DANE COUNTY DEPARTMENT of PUBLIC WORKS, HIGHWAY and TRANSPORTATION

APRIL 27, 2012

RFP NO. 312008 - ADDENDUM NO. 1

CNG FUELING STATION

SHEET NO.
3
 PROJECT NO.
 120204

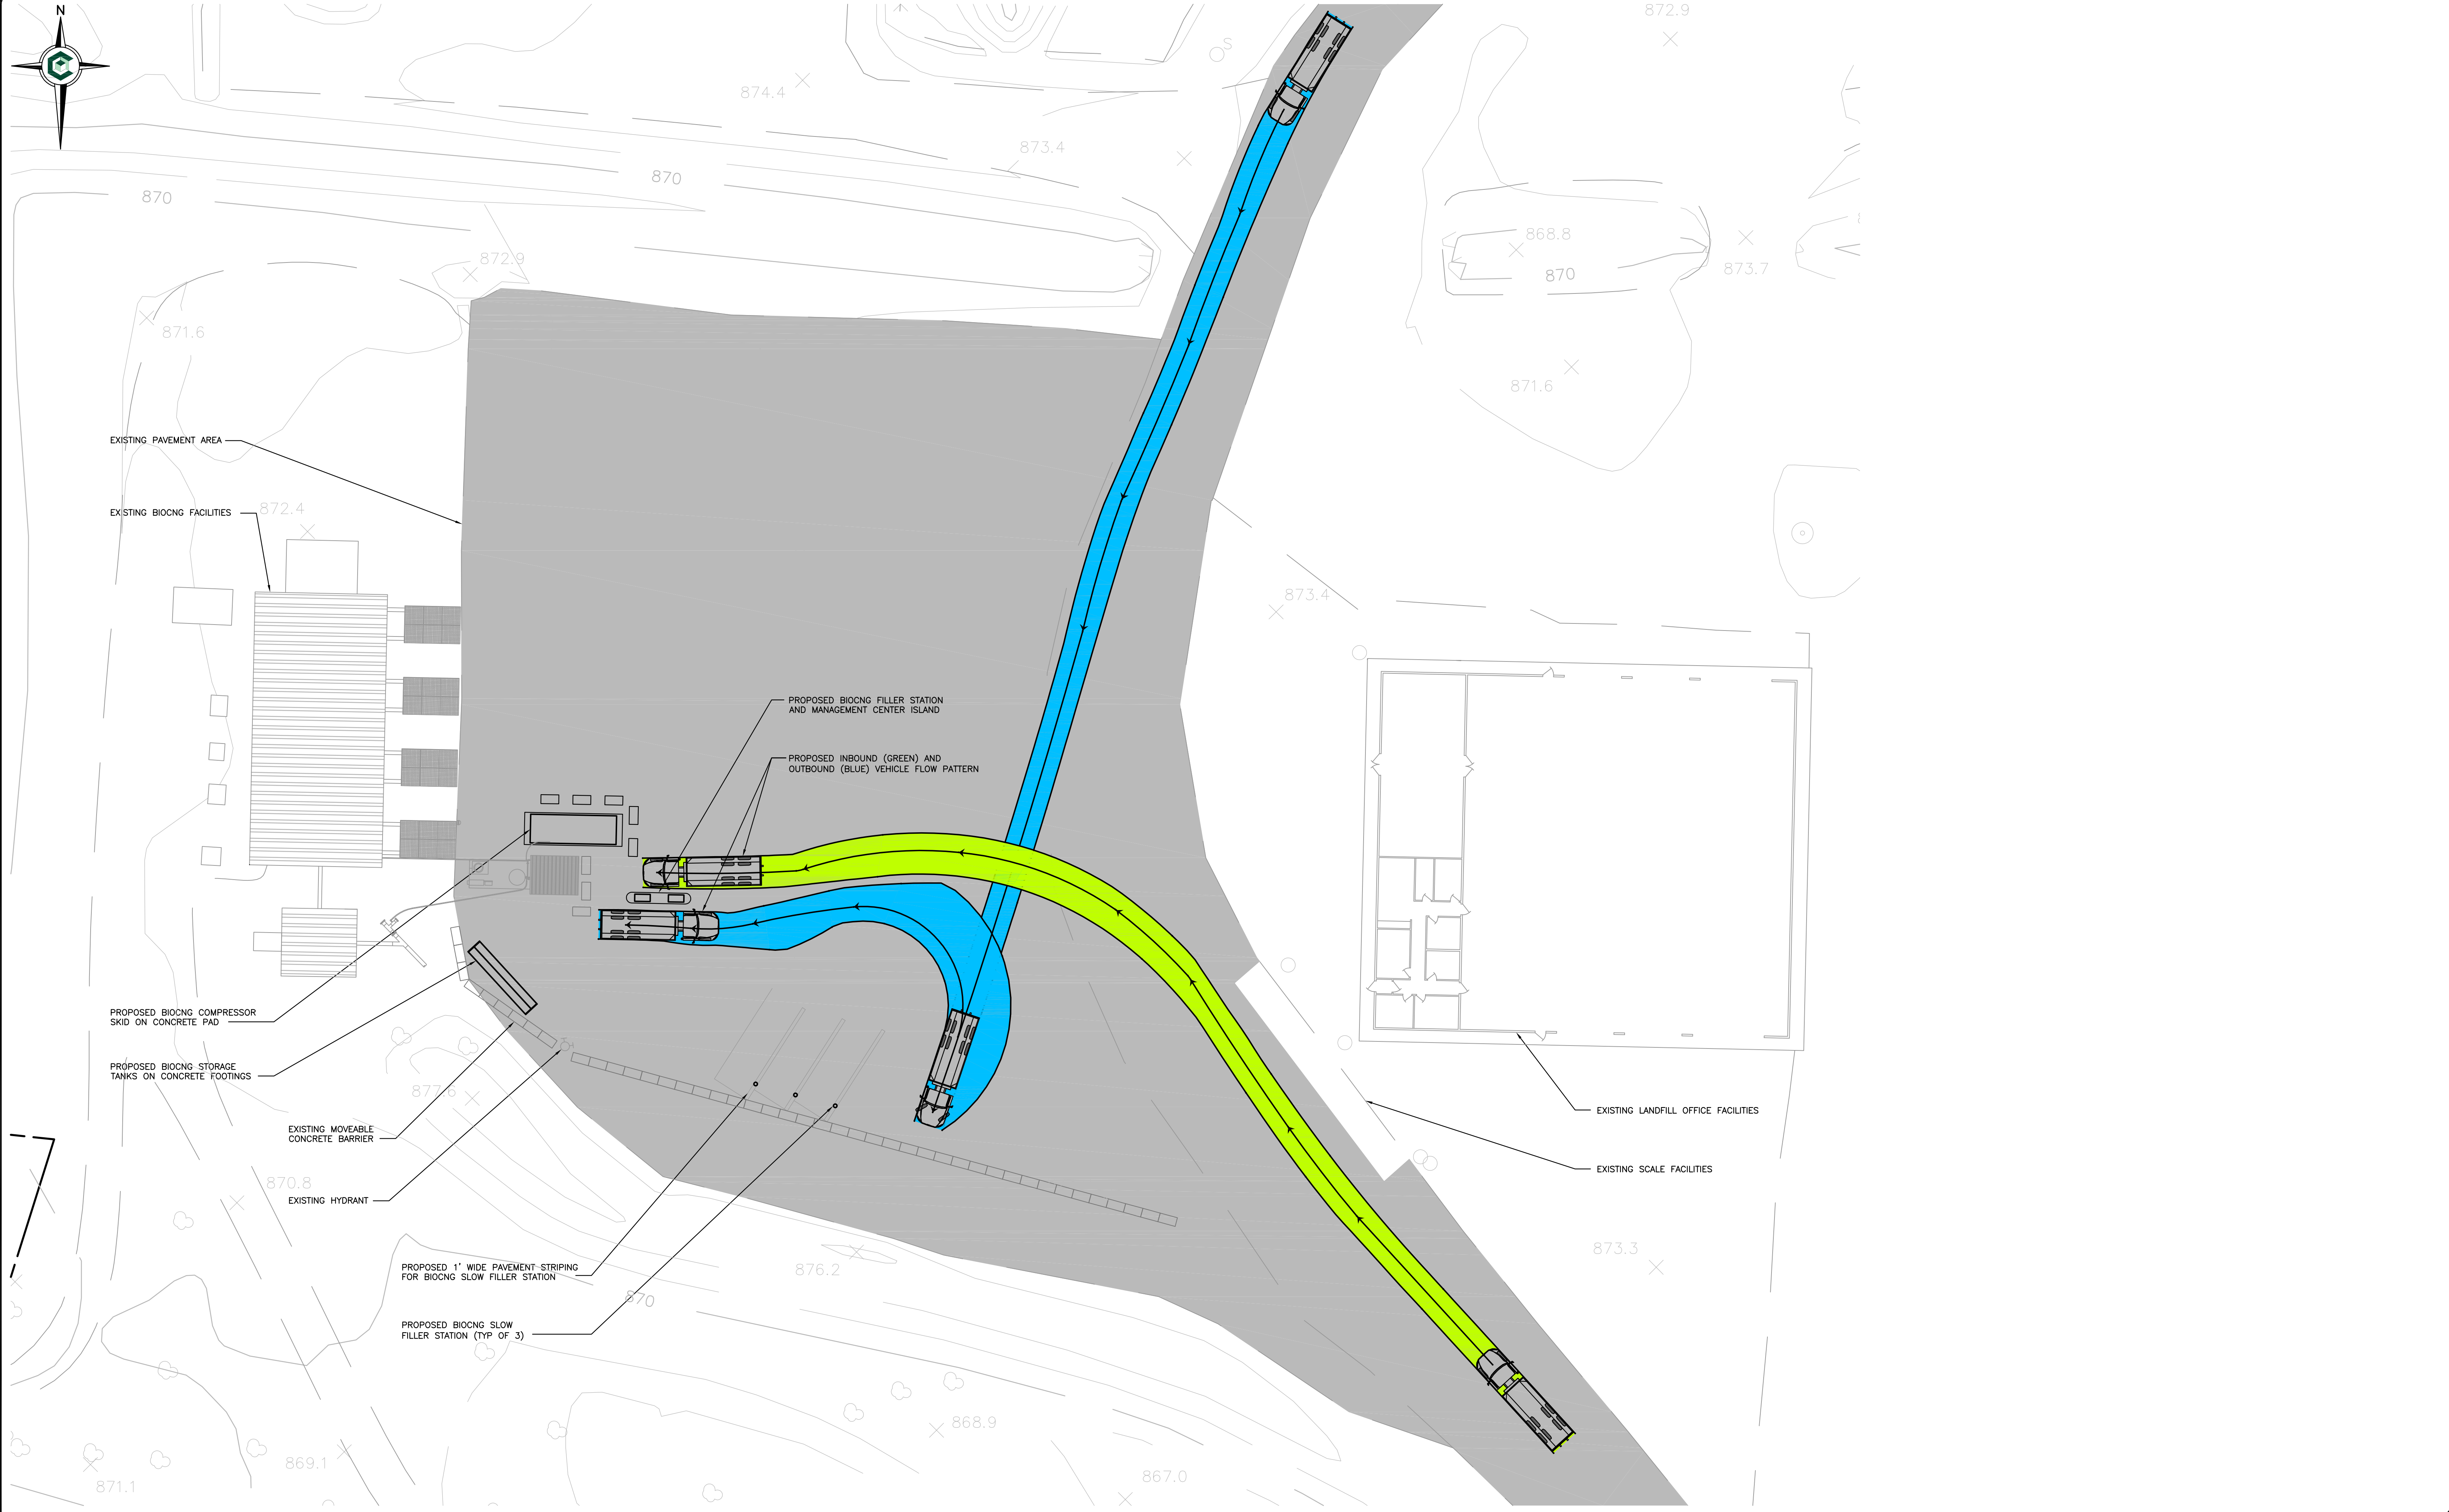
13. Sheet 1 (Cornerstone Sheet 3) – Possible BioCNG system layout

This sheet is for reference only. This is a possible layout for the BioCNG system. Proposing firm is welcome to suggest alternative layouts. Note that the drawing shows an incorrect number of slow-fill pumps. As described in the RFP, there will be a total of two slow fill pumps, which shall each be twin-hose dispensers

SHEET NO.
2
PROJECT NO.
120204

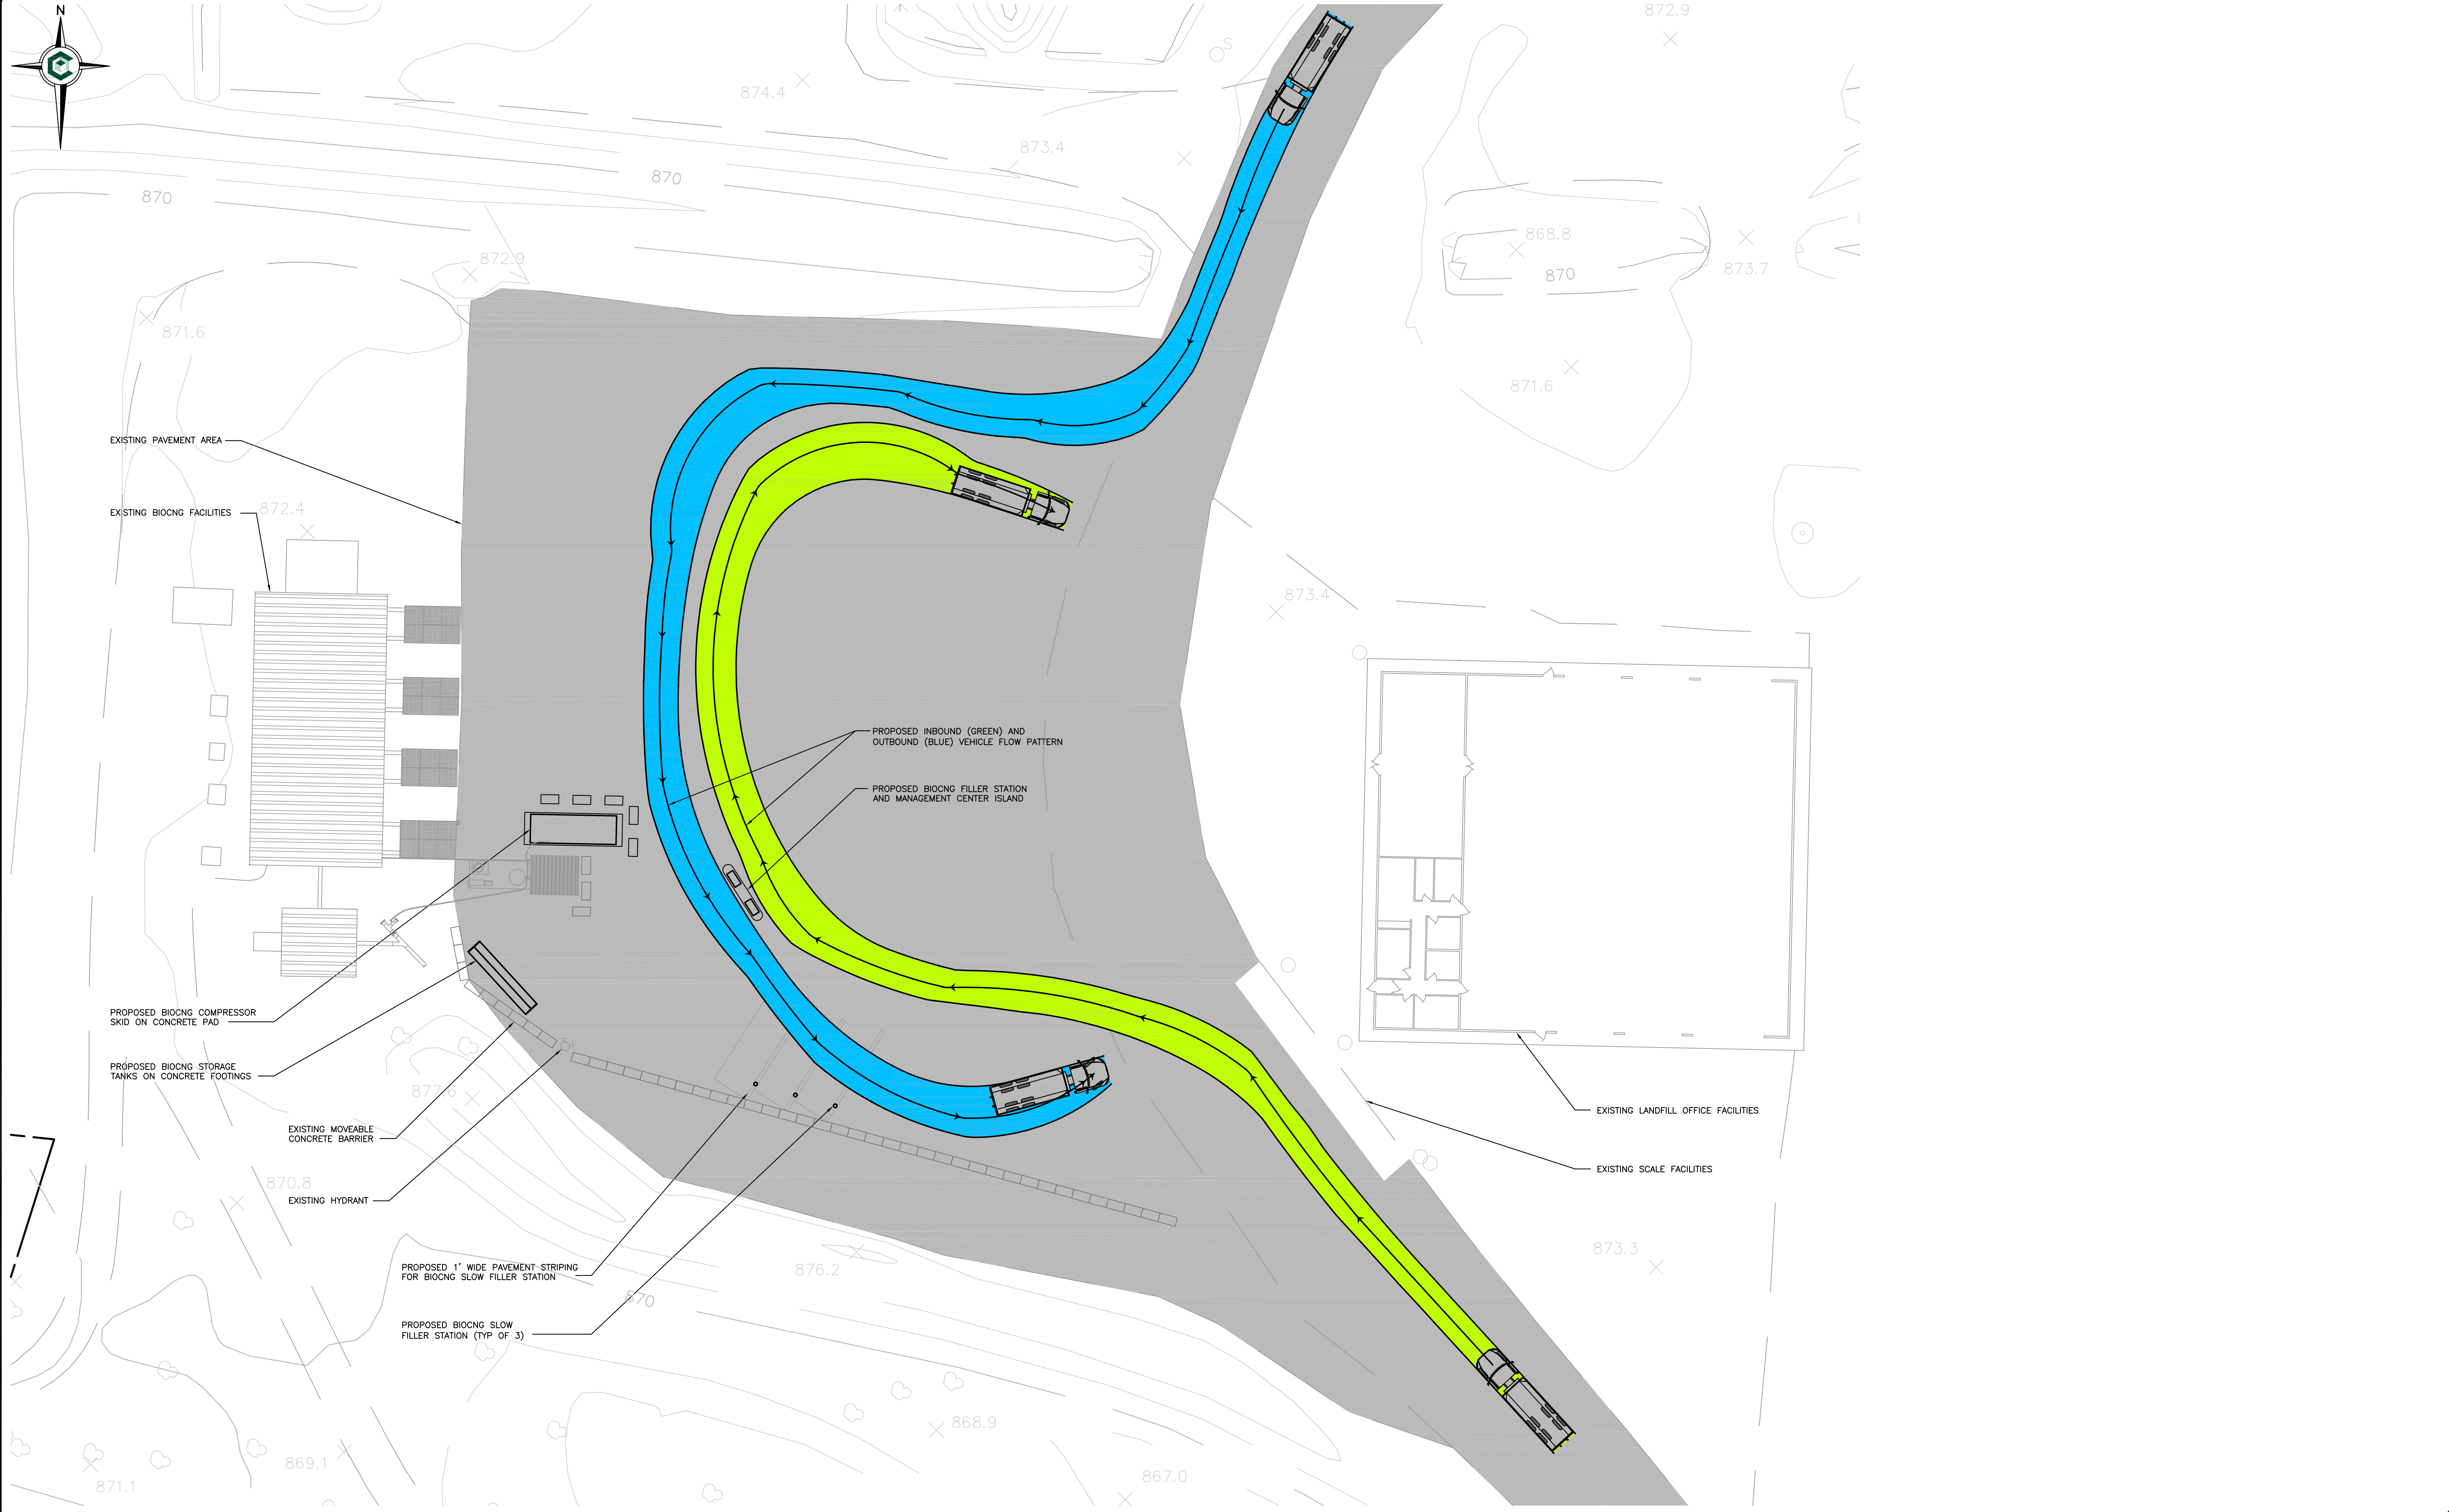
14. Sheet 2 (Cornerstone Sheet 2) - Possible BioCNG system layout

This sheet is for reference only. This is another possible layout for the BioCNG system. Proposing firm is welcome to suggest alternative layouts. Note that the drawing shows an incorrect number of slow-fill pumps. As described in the RFP, there will be a total of two slow fill pumps, which shall each be twin-hose dispensers

15. Sheet 3 (Graef Sheet C500) – Other Work By Others

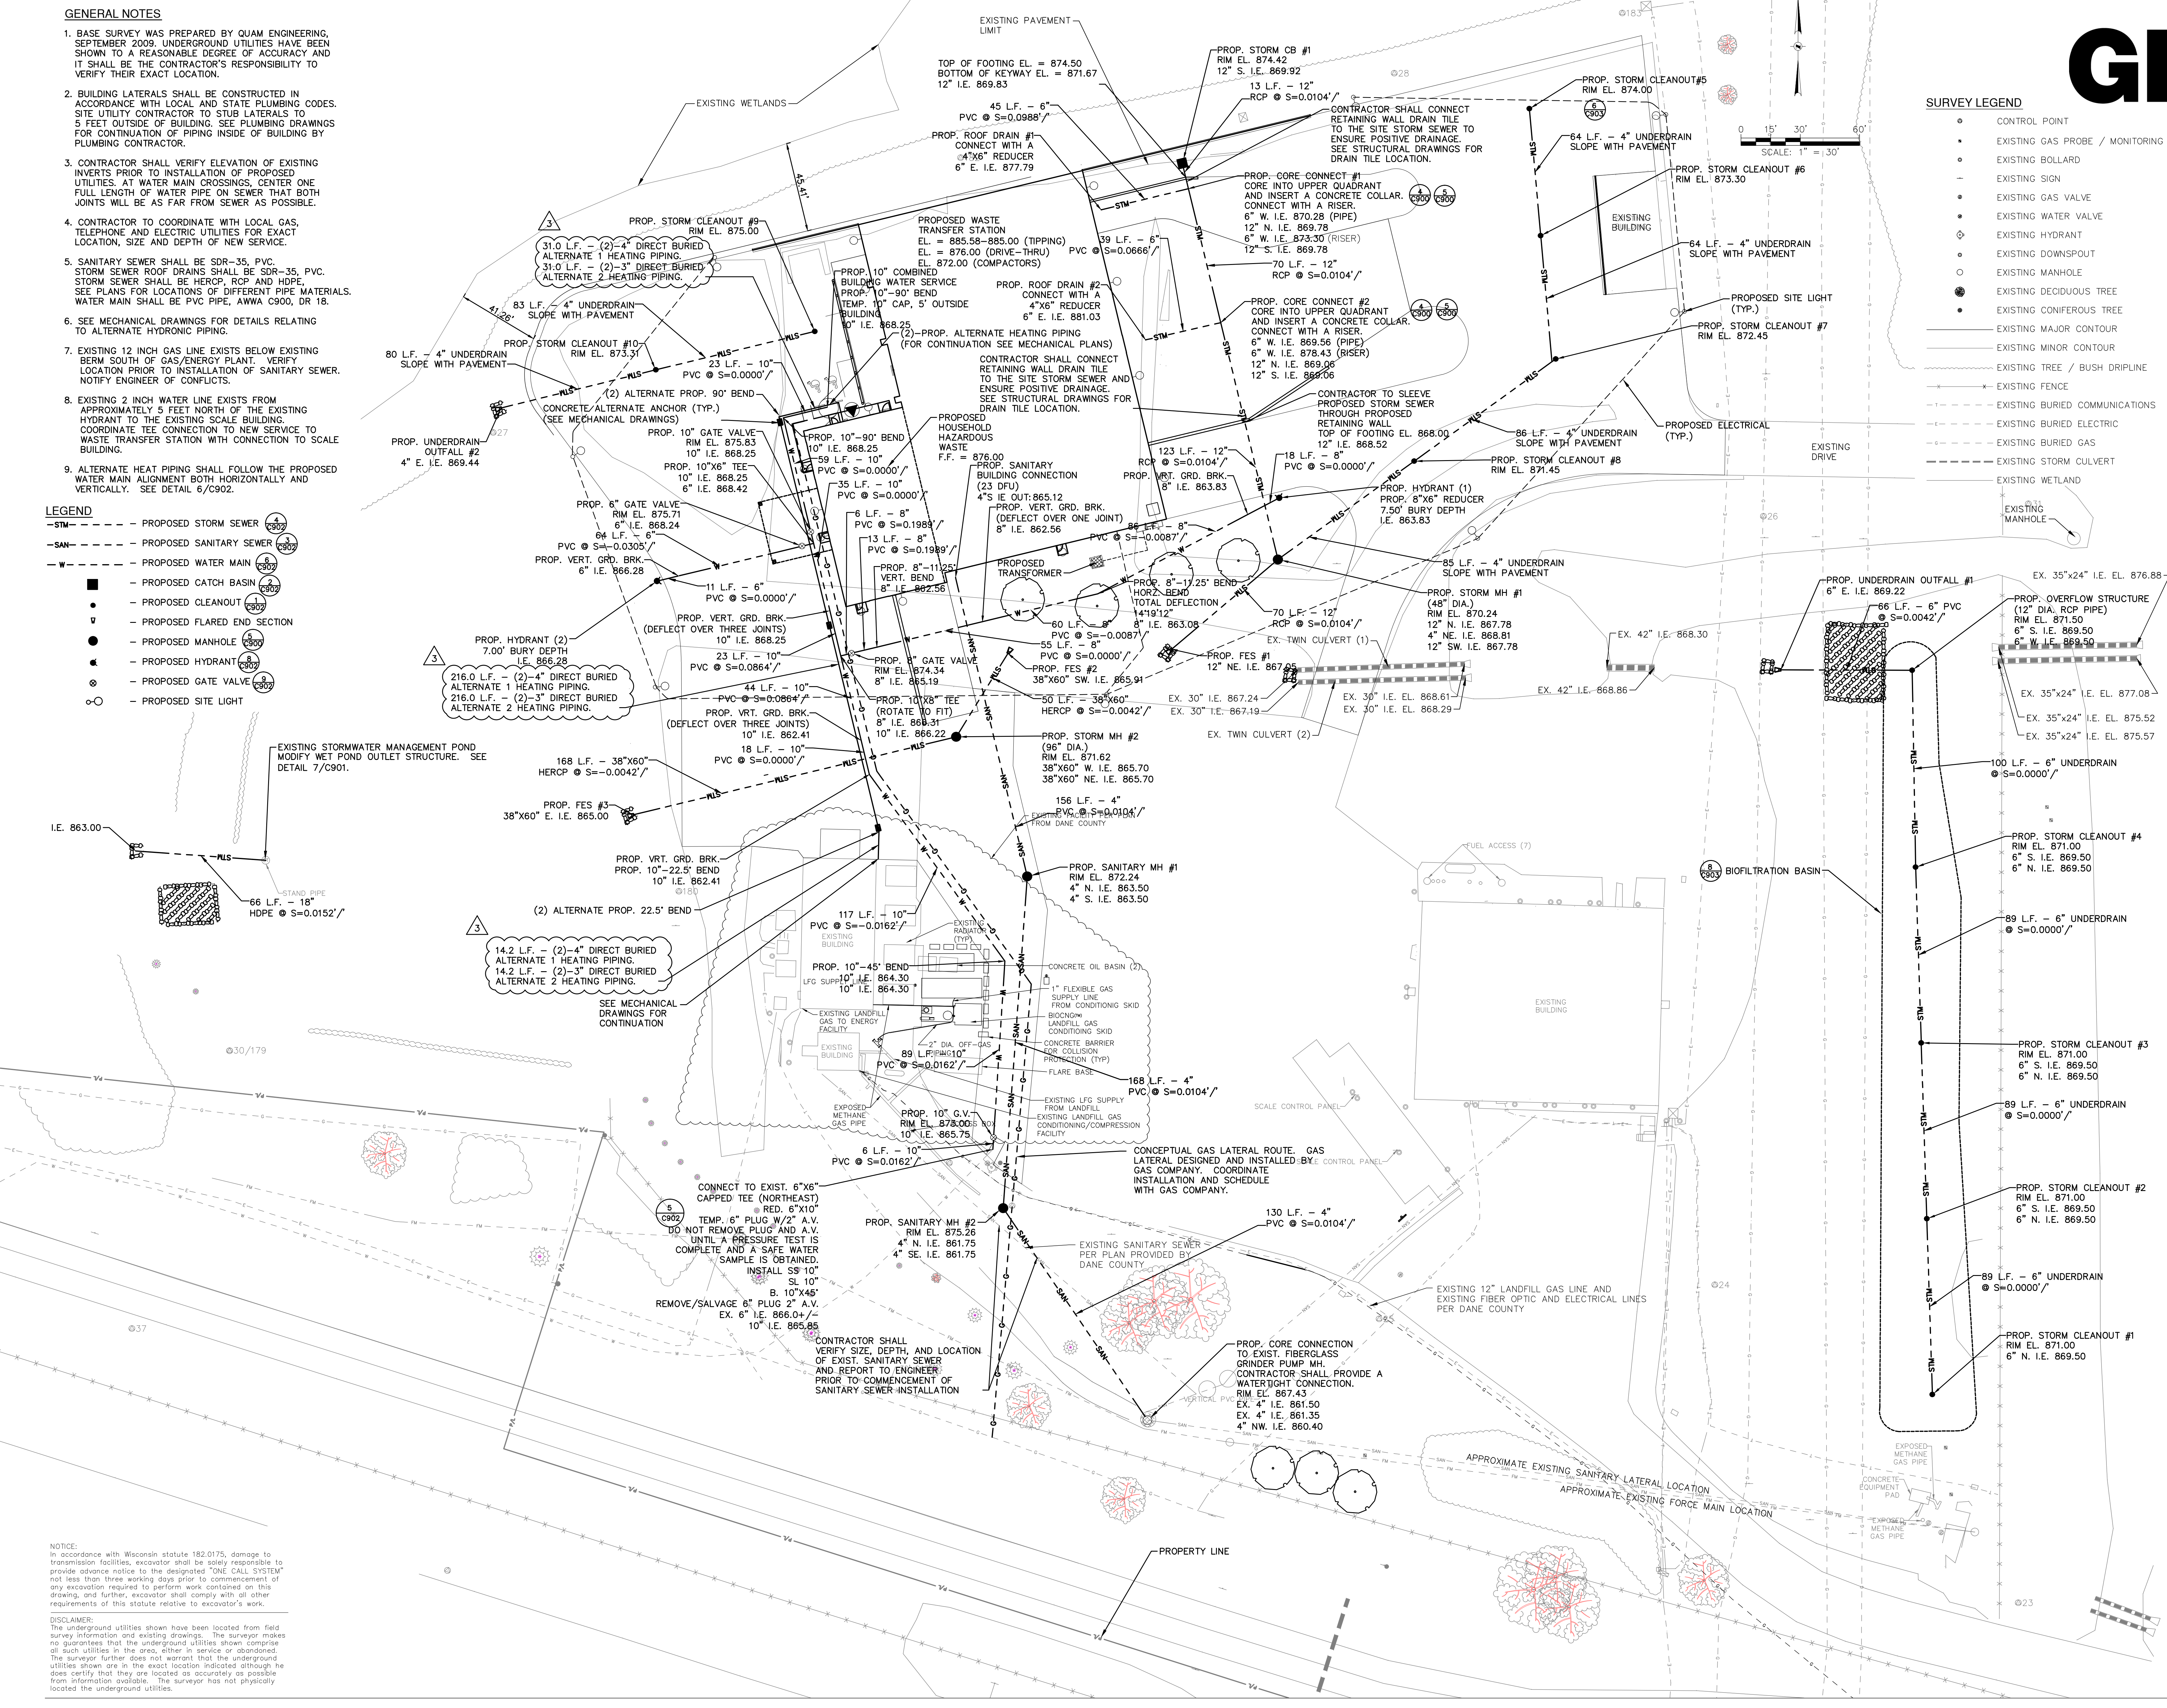
This sheet is for reference only. As mentioned in the pre-bid meeting, Dane County has another construction project at this site that will be starting in June 2012. That project involves the construction of an approximately 27,500 square foot waste transfer station and household hazardous waste building. This drawing shows that work by others. Successful Proposer on RFP 312008 must coordinate work with other contractors that will be on-site.

Specific attention should be made to coordinating the site utilities, including natural gas to the site.
